Part: SE141-115 / MODULAR COIL, TYPE B

Drawing ID: SE141-102 Revision: 3
W/O Links: 1-Type:W: 65708/3.0 Sub: 0

Problem: SEVERAL ITEMS NOTED DURING VISUAL REVIEW OF CASTING. SEE ATTACHMENT.
Rev. 1 - added pages 9 & 10 to the attachment. (1-2-07)

NC20920 – B3 Visual Review

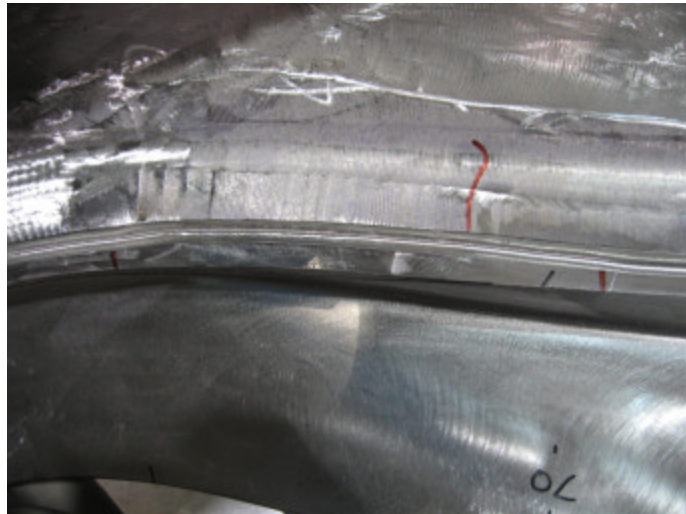
Tool Gouges on E side Long Leg near radius

Tool Gouges on E side Long Leg near radius

.400" distance from short leg to VPI groove (sheet 2, zone G7)

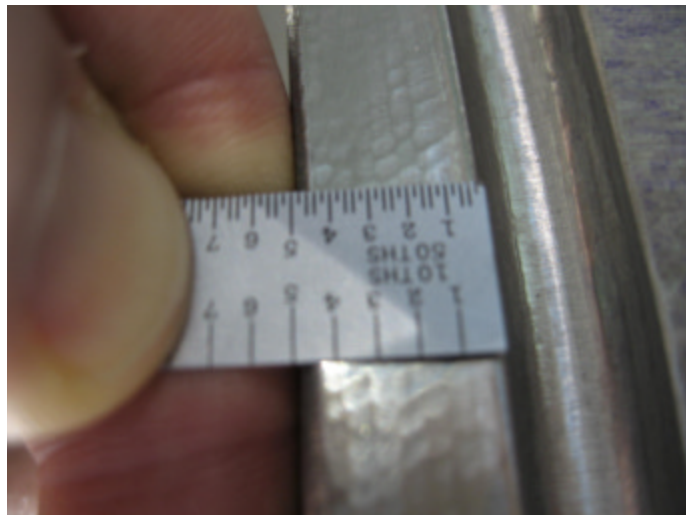
There is an area on the Datum D side from T hole 81 to 86 that checks as small as .300". The transition has been blended smooth.

There is an area on the Datum D side from T hole 70 to 73 that checks as large as .506".

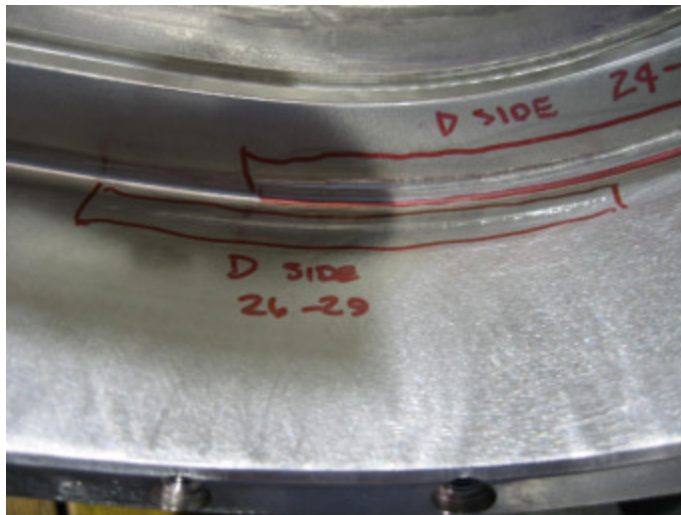
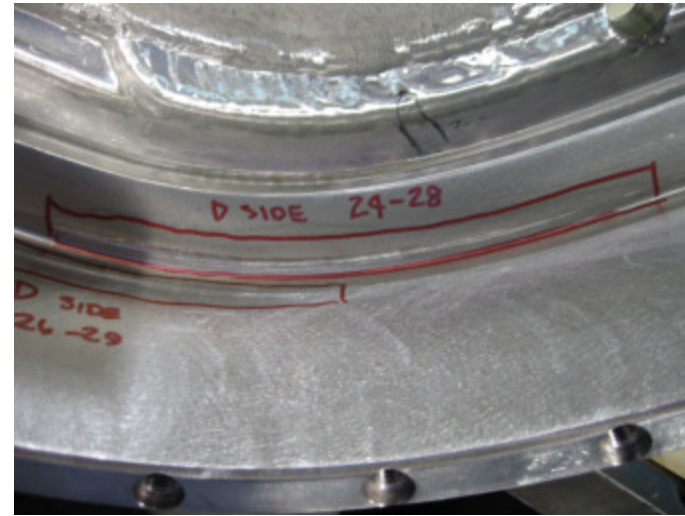
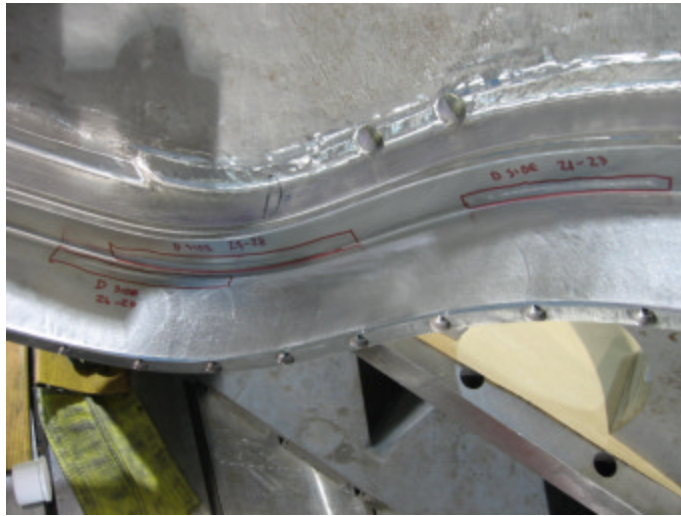
Tool Gouges on D side Long Leg near radius

Tool Gouges on D side Long and Short Legs near radius

Tool Gouges on D side Long and Short Legs near radius

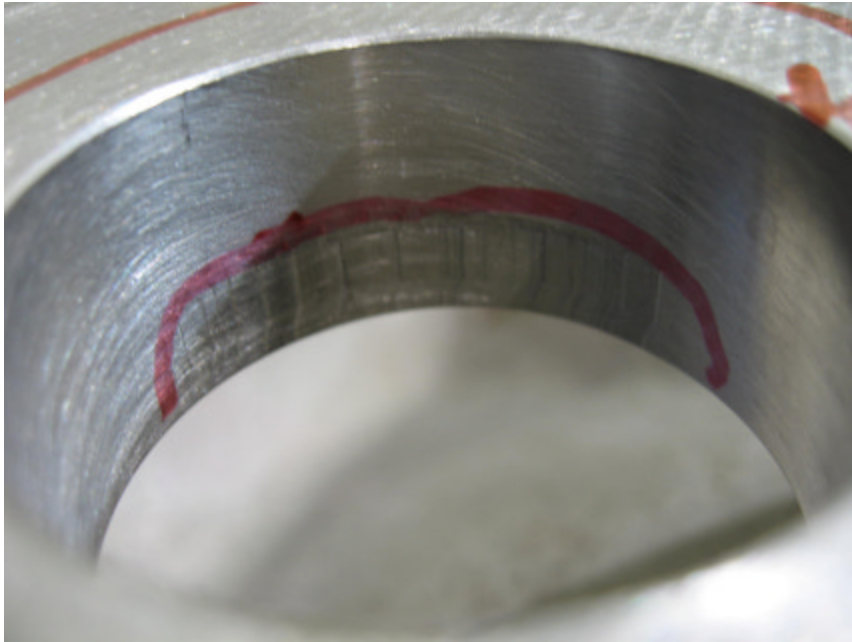
Oversize area in hole #27 in Datum E flange. (reported on NC20917 step 730)

Undercut areas adjacent to .12" radius of Long Leg

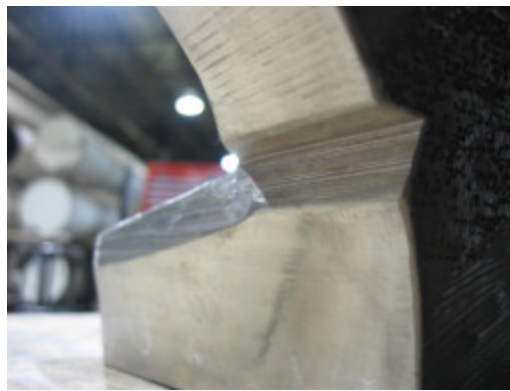
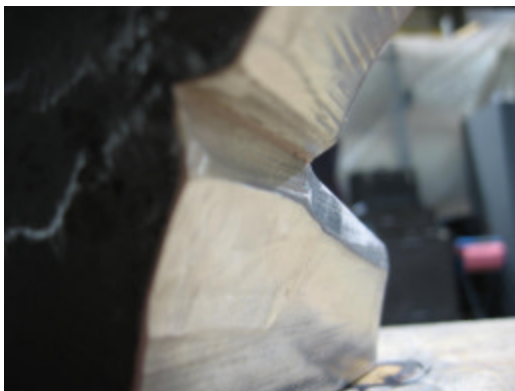
The picture to the left is of the port opening on the Datum D flange just beneath the Lead Block pad.

A programming error resulted in too much material being removed during the rough machining operation. An area on both sides of the port did not clean up.

One area measures approximately .25" x .25" and the other is .35" x .35". Both cutter marks extend through the opening the thickness of the casting wall.

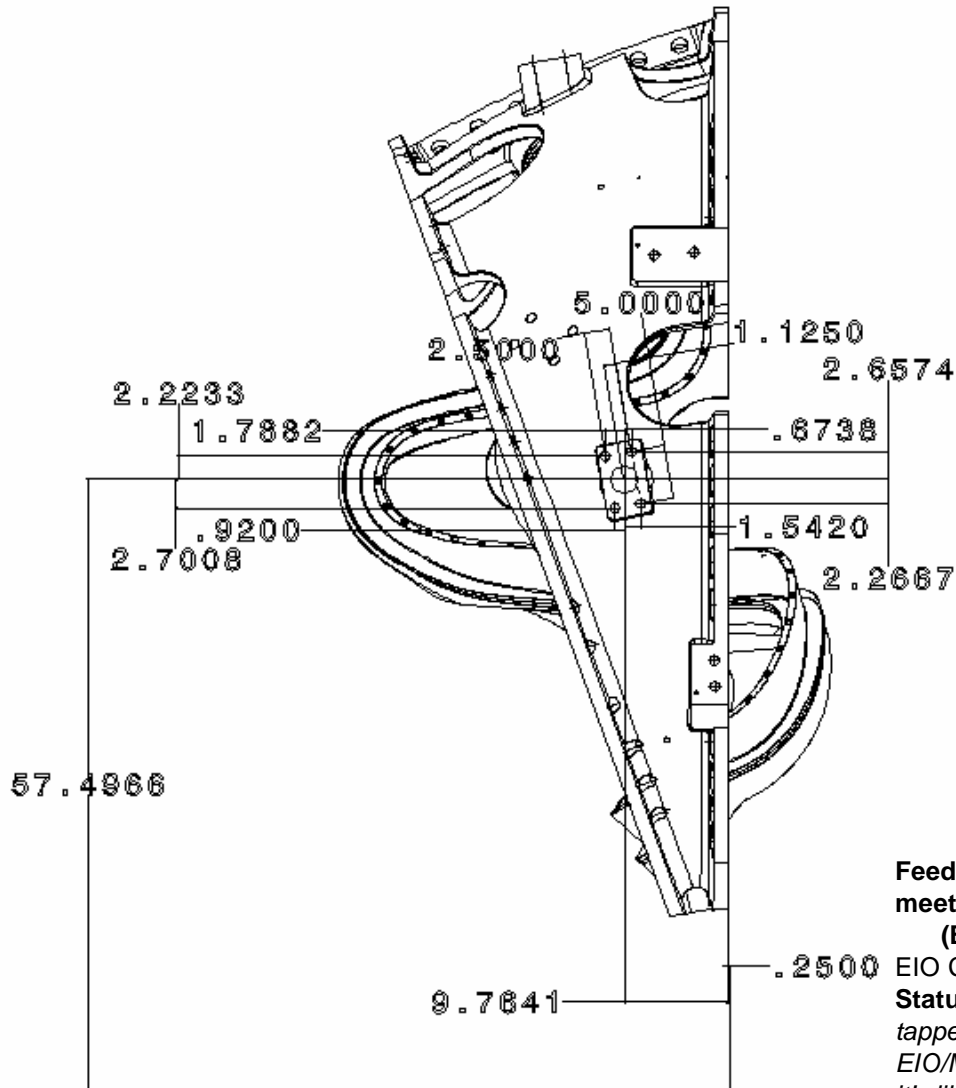
From the orientation shown, the 1-8" hole pattern was shifted .25" down. This hole pattern, per the model, was not centered about the 2.5" hole prior to this shift.

Feedback on Vacuum Vessel support pads per request of weekly quality meeting.

(EIO, MTM) Provide documentation of completion of corrective action for EIO CA 090606(NCR) for B-3 & B-6 Vacuum Vessel support pads deviations.
Status: (Open) MTM confirms that the center hole position is fixed but the tapped hole pattern is being shifted as needed (applies to all Type B castings). EIO/MTM will provide proposed shifted locations prior to drilling. On B3 & B6 it's likely that one hole cannot be drilled (corner missing). The CA will remain open until after B6 is completed.
